Question 1

“Are you convinced that threshold dispersion and parallel noise sources will not affect the overall noise performance of your detector and if this is a concern will you consider adding in a channel by channel baseline offset in the FPHX using a 3-bit DAC for the next round of prototyping What would be the schedule and cost impact of such a change.”

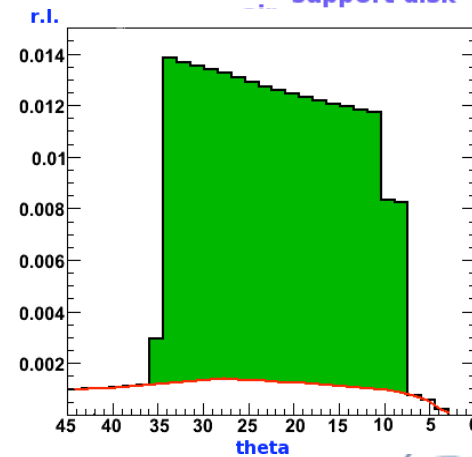
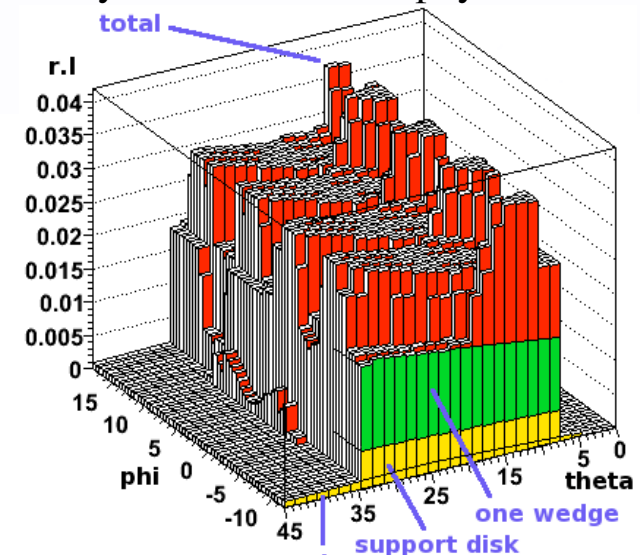
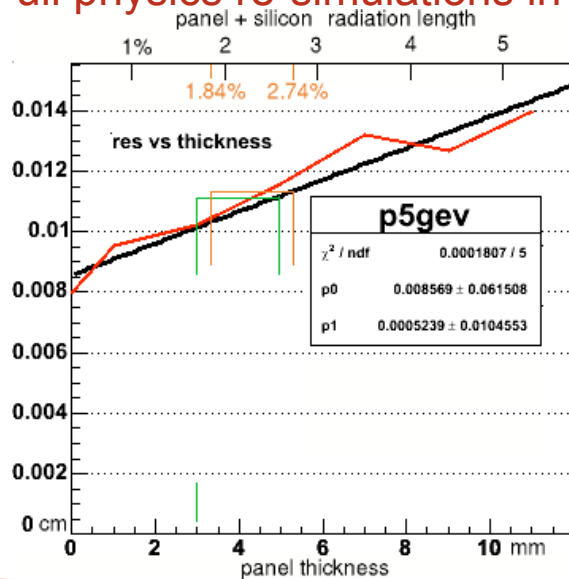
“What is the radiation length budget with the current design and have you calculated the physics impact?”

- Radiation length budget with the current design is given directly in plots shown in simulation talk.
- ~1.2%/wedge
- Previous specification came from desire to keep DCA resolution within ~10% of nominal value
- We are still within those specifications
- Full physics re-simulations in progress
